Evidence of a Wider and Inconsistent Levels Problem Affecting Plots 23, 34 and 35

Plot 34

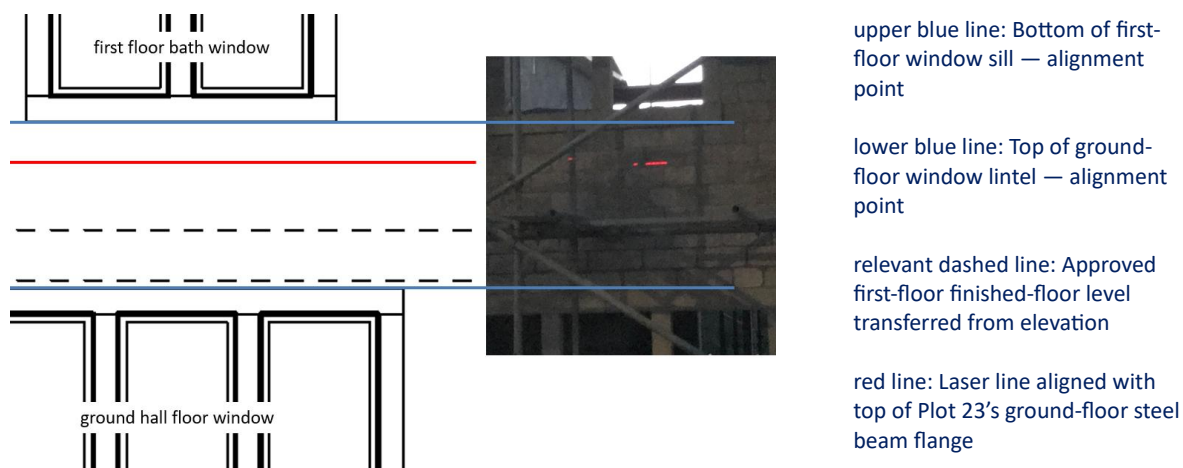
Plot 23's ground floor was therefore intended to be 2.80 m above Plot 34's ground floor. The grouped elevation indicates that Plot 34's first-floor finished-floor level is approximately 2.791 m above its ground floor. Consequently, Plot 23's approved ground floor and Plot 34's approved first floor should be virtually level, differing by only approximately 9 mm.

However, the horizontal laser line associated with Plot 23's as-built ground-floor/decking level appears approximately 0.63 m above Plot 34's indicated first-floor level. The two levels that should have aligned no longer do so.

$$\text{Plot 34 excess} = \text{Plot 23 excess} - 0.63\text{m}$$

$$1.00 - 0.63 = 0.37 \text{ m too high}$$

Plot 35

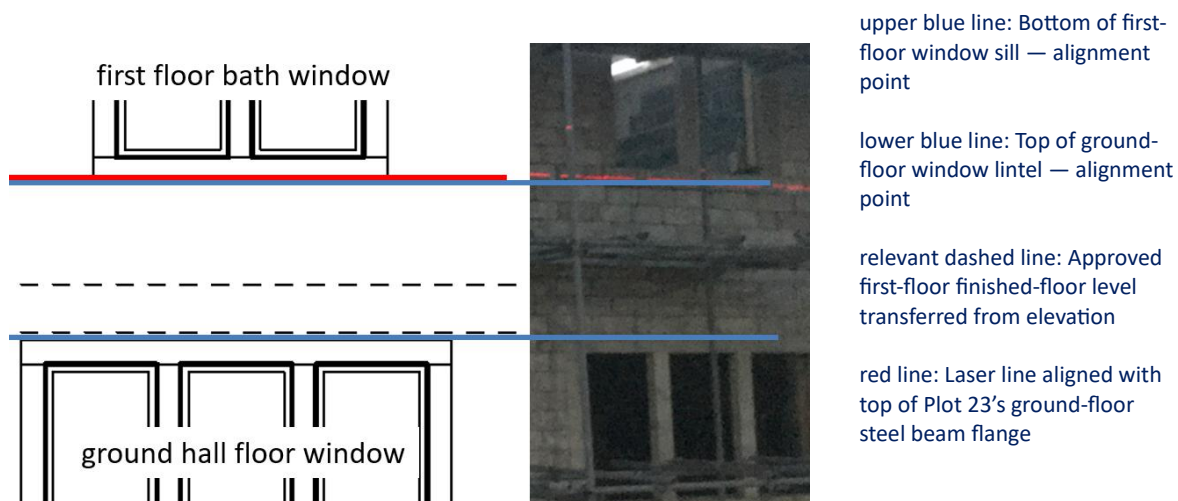
Plot 35's approved ground-floor level is 198.10 m, 0.30 m below Plot 34. As Plots 34 and 35 use the same house type, their corresponding first-floor levels should retain that 0.30 m difference.

Plot 23's approved ground floor should therefore sit approximately 0.30–0.31 m above Plot 35's approved first-floor level.

The photographic comparison instead indicates that the horizontal laser line is approximately 0.69 m above Plot 35's transferred first-floor level. It is therefore approximately 0.38 m higher than the approved relationship requires:

$$0.69 - 0.31 \approx 0.38\text{m}$$

$$\text{Plot 35 excess} = \text{Plot 23 excess} - 0.38 \text{ m}$$

$$1.00 - 0.38 = 0.62 \text{ m too high}$$
